CITY OF SMYRNA

MEMORANDUM

RE: VARIANCE CASE V22-055
1921 Sadler Drive – Allow encroachment into the 75-foot impervious surface area setback

Figure – 2
Site Plan

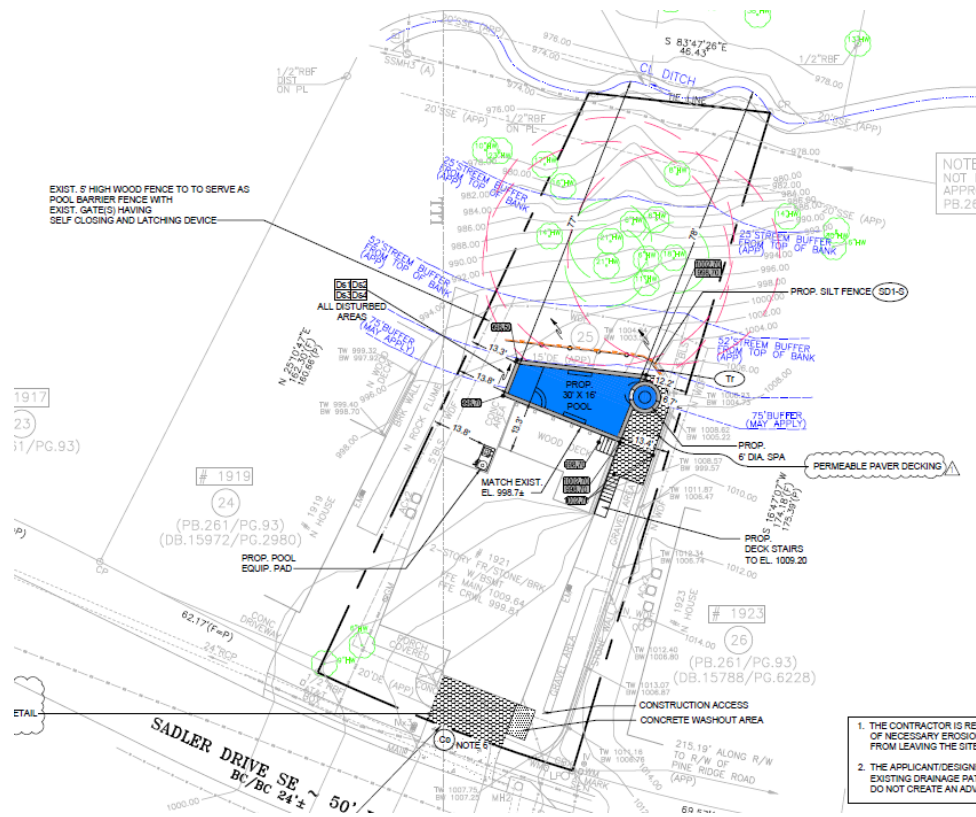
The applicant is proposing to build a 691 square foot inground swimming pool and accompanying decking in the rear yard. Due to the existing stream, the rear yard is encumbered by the State's 25-foot undisturbed stream buffer, the City's 50-foot undisturbed stream buffer, and the City's 75-foot impervious setback. Thus, the applicant will require relief from the City's Stream Buffer Protection Ordinance in order to construct the pool and decking in the rear yard. However, due to the physical constraints of the site, including the size of the lot and existing home, there is no feasible area to install proper mitigation on the property to offset the disturbance to the buffer. After a site visit on August 15, 2022, the Assistant City Engineer made the determination that the 25-foot and 50-foot buffers are currently properly vegetated and facilitate the protection of water quality and aquatic habitat, so a buffer remediation plan would also not be applicable. After the site visit and review of the plans, the Assistant City Engineer

cannot support the variance due to a lack of a feasible mitigation plan. After the request was tabled at the October 3, 2022 Mayor & Council meeting, staff has coordinated additional meetings with the pool contractor to determine if other options are available for mitigation of the encroachment in the 75-foot impervious coverage setback. The contractor has proposed replacing concrete at the front and side of the property with permeable pavers. However, due to the slope of the lot, those pavers would offer no remedy to the impervious coverage setback encroachment because that section is already draining towards the street. Due to the site constraints, staff does not believe there are sufficient alternatives to mitigate the encroachment of the 75-foot impervious coverage setback.

The applicant is requesting relief from the City's 75-foot impervious surface area setback to install a pool and decking in the rear yard. According to Section 46-160 of the Stream Buffer Protection Ordinance, variances must be reviewed under the following standards: (a) the shape, size, topography, slope, soils, vegetation and other physical characteristics of the property; (b) the locations of all streams on the property, including along property boundaries; (c) the location and extent of the proposed buffer or setback intrusion; (d) whether alternative designs are possible which require less intrusion or no intrusion; (e) the long-term and construction water-quality impacts of the proposed variance; (f) whether as a result of an exchange of buffer area the net buffer area is not reduced; and (g) whether issuance of the variance is at least as protective of natural resources and the environment. Engineering and Community Development have reviewed the request against the variance review standards and found it to not be in compliance with the standards due to the lack of a mitigation plan to offset any effects. After a review of the standards above, Community Development believes that the encroachment may adversely affect surrounding residents; therefore, staff recommends **denial** of the requested variance.
